Subject: LIFTGATE OPENER SWITCH INOPERATIVE	Bulletin No: 09-035/14
	Last Issued: 08/29/2014

- This bulletin supersedes the previous bulletin 09-037/12 issued on 08/31/12. The APPLICABLE MODEL(S)/VINS, DESCRIPTION, REPAIR PROCEDURE, PART(S) and WARRANTY INFORMATION have been revised.
- Changes are noted below in Red beside the change bar.

2013-2014 CX-5 vehicles with VINs lower than JM3KE*****398857 (produced before Oct. 2, 2013)

Mass-Production Change Overview:

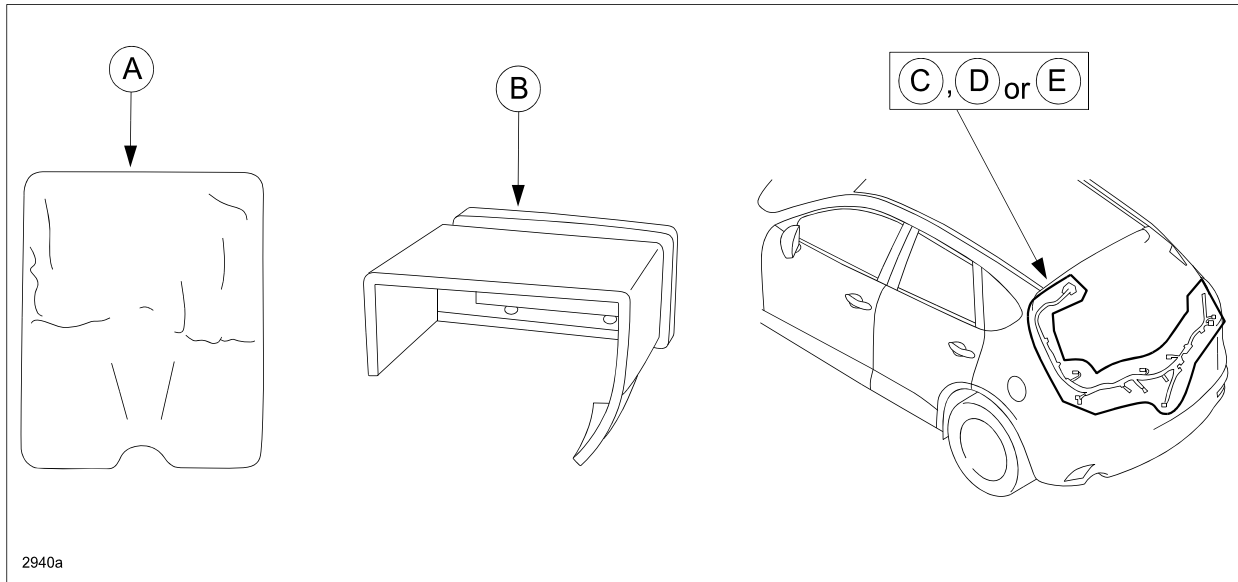
The following three (3) mass-production changes have been made (at various times), to eliminate this concern:

- 1) A water-proof sheet (A) was installed to cover the liftgate opener switch and protect it from water intrusion.
- 2) For increased protection, the water-proof sheet was later replaced by a water-proof protector (B).
- 3) The shape of the rear harness No. 2 (C, D or E) was modified for additional corrosion protection.

- There are three (3) different rear harness No. 2 part numbers (KD33, KD37 and KD45 type).
- Check the GEPC for the correct rear harness type for the subject vehicle.
- Harnesses ending with a “C” suffix are the new (modified) parts.
- The water-proof protector can ONLY be installed on a new “C” suffix harness.
- The water-proof protector is NOT compatible with an old “B” suffix harness.

REPAIR PROCEDURE D. INSTALLATION OF WATER-PROOF SHEET:

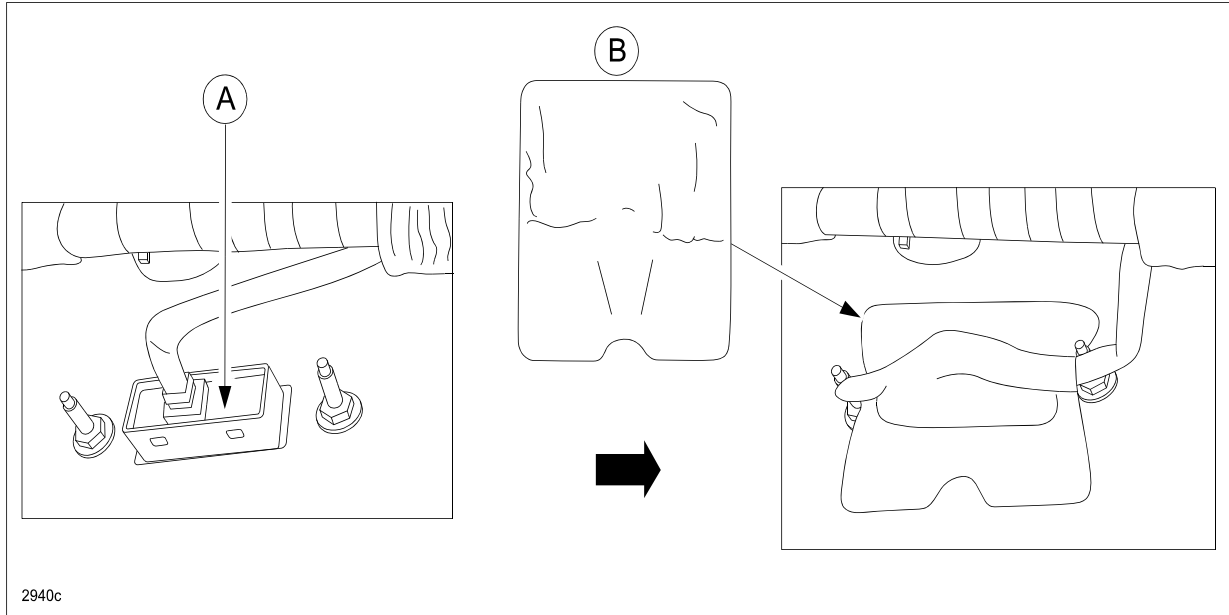
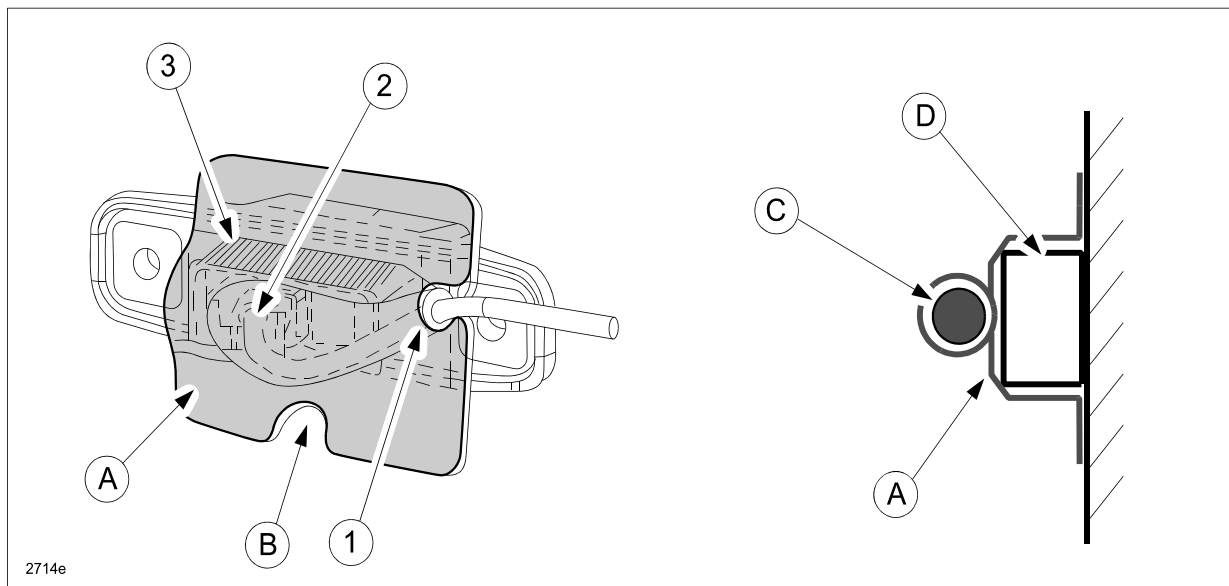
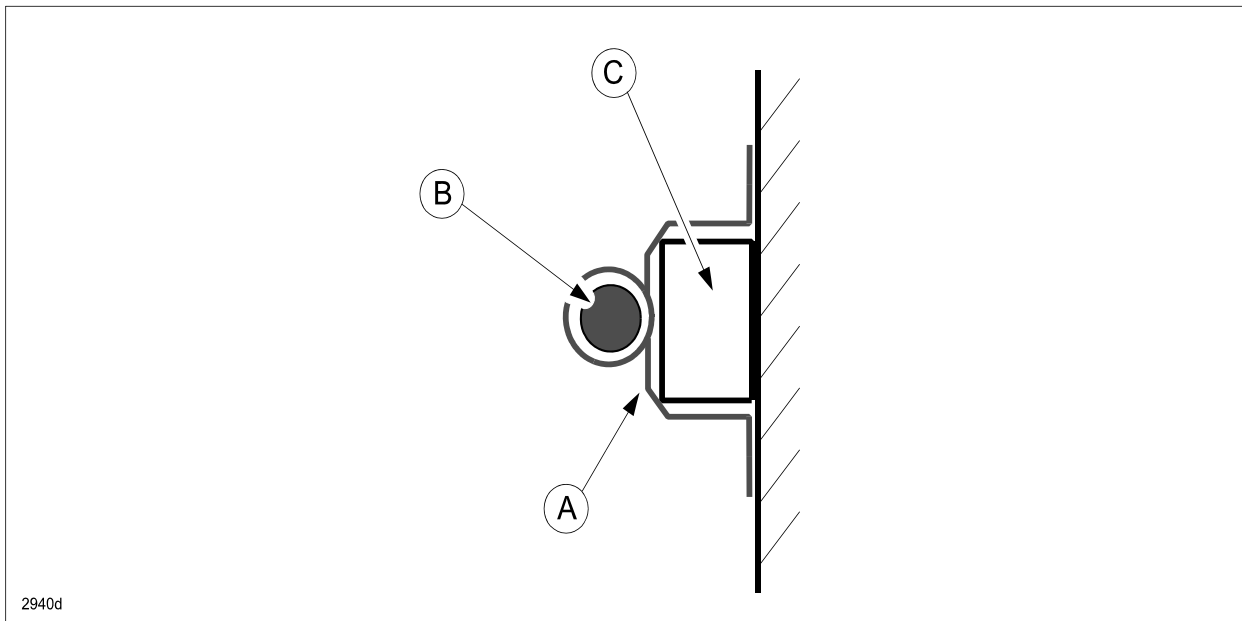
1. (For Vehicle Y only): Remove and discard the old water-proof sheet (B).
2. Attach the new water-proof sheet (B) over the liftgate opener switch (A) as shown below.

3. Attach the water-proof sheet (A) with the cut-out (B) facing downward and in the order shown below (1,2,3).

- (1) Attach the water-proof sheet all around the harness (C) by pinching and pressing until all gaps/clearances are gone. If there are any gaps/clearances, water may flow into the connector along the harness.
- (2) Cover the connectors tightly with the water-proof sheet.
- (3) Attach the sheet at the upper and lower part of the switch (D).

4. Knead the water-proof sheet (A) with fingers so the sheet adheres to the harness (B) and switch (C) without any clearances to avoid water intrusion.

REPAIR PROCEDURE E. INSTALLATION OF WATER-PROOF PROTECTOR:

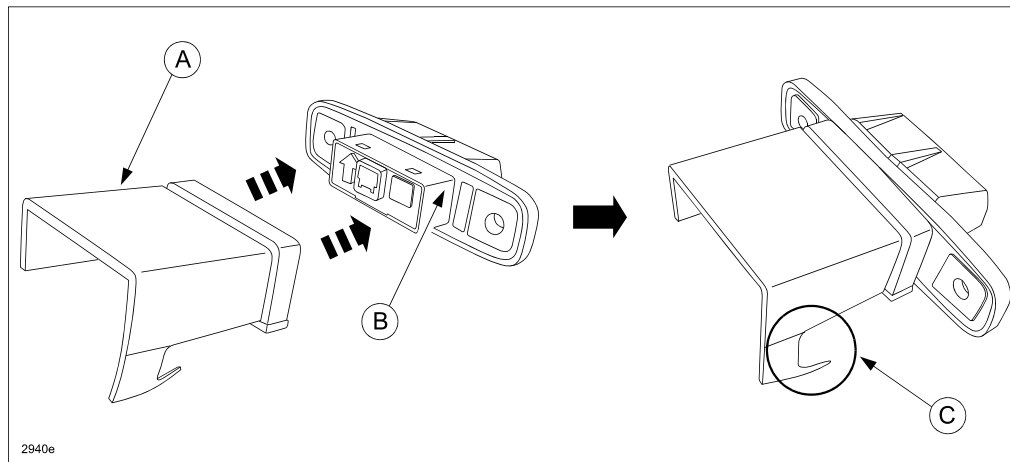
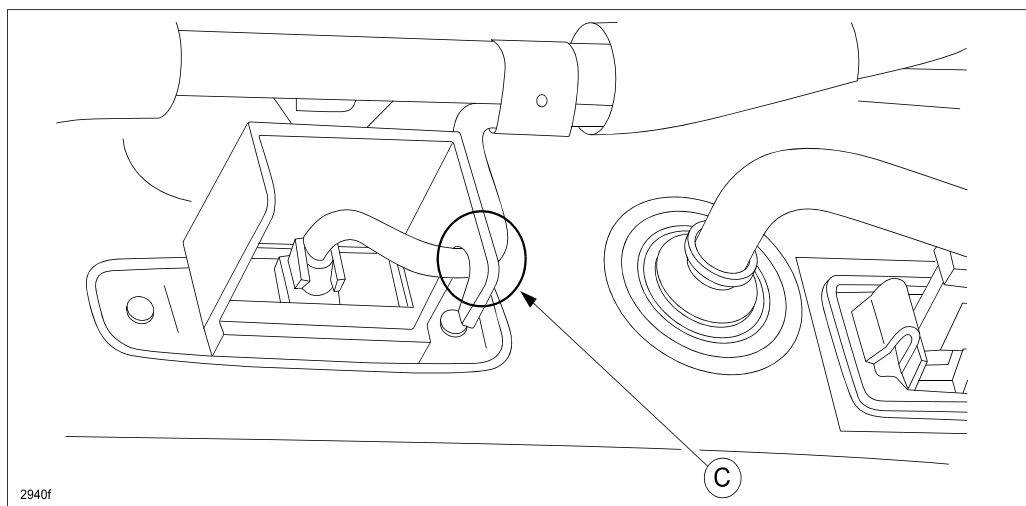
1. (Vehicles Y and Z only): Remove the old water-proof sheet and discard.
2. Install the water-proof protector over the opener switch.

NOTE: For illustration purposes, the protector (A) and opener switch (B) are not shown installed on the vehicle.

3. Hook the rear harness No. 2 to the hook (C) of the water-proof protector, then re-connect the connector.
